M.I.C.M.U.E. – G.A.B.
AERONAUTICS MANUFACTURING COMPANY
BRASOV

Mandatory service Bulletin
no. IS-29D/C.O.-3

Product: Glider plane IS-29D
Scope; Improvement of elevator fastening
Issued based on: According to Change Sheet no. 326

Date: 12.10.1974

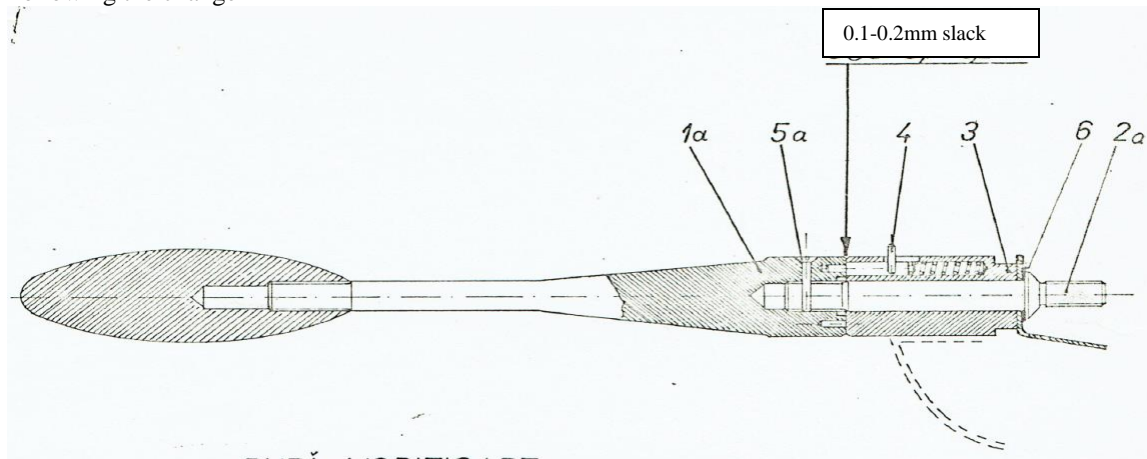
This change shall improve the service safety of glider plane by a dimensional alteration of elevator fastening elements to the control system. The change complies with the requirements for long term transport of undamped trailer.

- removal of counterweight arm and elevator fastening screw to the control lever on the fin.
- replacement with new parts.

With a screwdriver, loosen screw no. 5 fastening arm 1 to screw 2. Tighten two check nuts M8 on screw 2 head. Locking screw 2 will unlock pin 4 and unscrew the counterweight arm 1. Then, remove screw 2 from control lever 3.

On screw 2a install the two check nuts. Insert screw 2a in control lever 3. Tighten screw 5 to lock it using screw 2a. Lock arm 1a with pin 4. Check if there is a slack exceeding 0.1-0.2mm between arm 1a and lever 3. If the slack exceeds the said value, remove the assembly and insert on screw 2a, rings 6 for slack offset. Put back the assembly, check the slack again and lock screw 3.

Following the change

Prior to the change
